F D RICHARDSON HEIGHTS SUBDIVISION,
RESUBDIVISION OF LOTS 1, 16 THROUGH 20 &
COMMON AREA

APPLICATION NUMBER 13 DATE April 15, 2010

DETAIL SITE PLAN

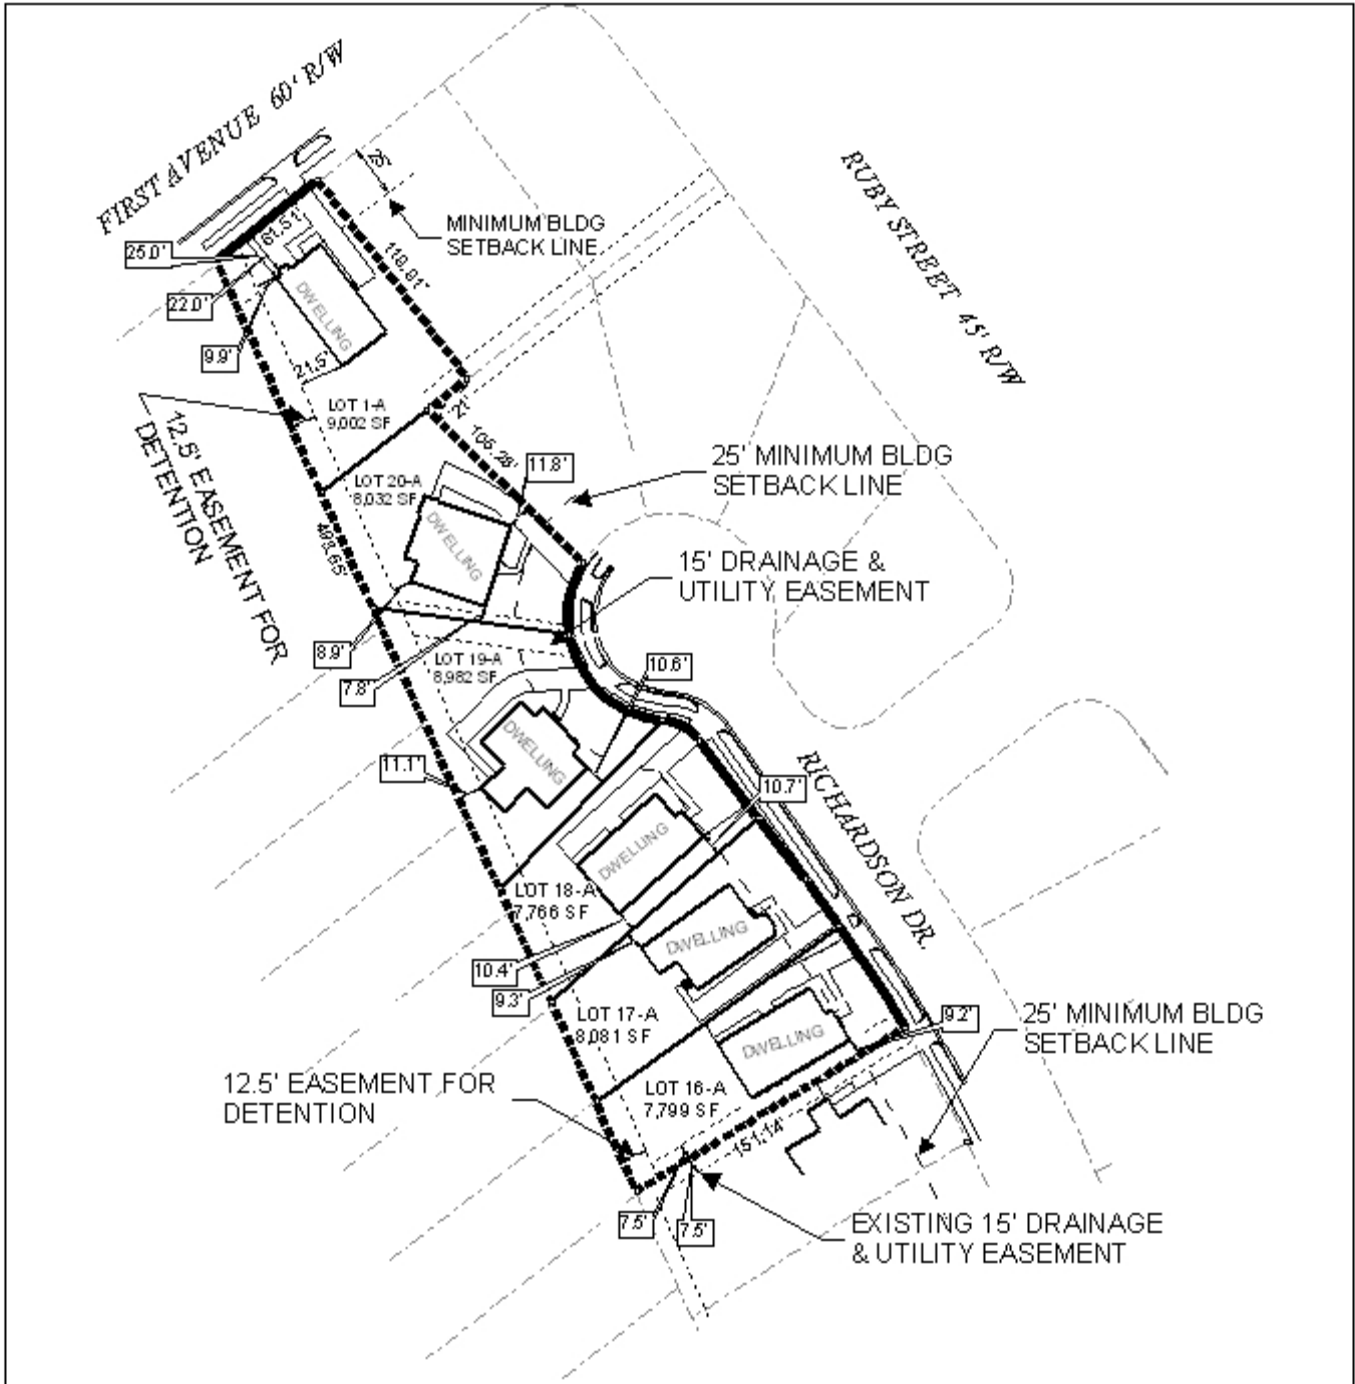
With that said, it should also be noted that there are several storage sheds on several of the properties, not shown on the plat, and that one house partially encroaches in to the common area / proposed easement with an apparently unpermitted addition. If approved, the applicant should revise the plat to illustrate all improvements within the subdivision, with the obtainment of all necessary permits from the Permitting Section of Urban Development.

Based on the preceding, it is recommended that this application be withdrawn and resubmitted including all properties of the original subdivision.
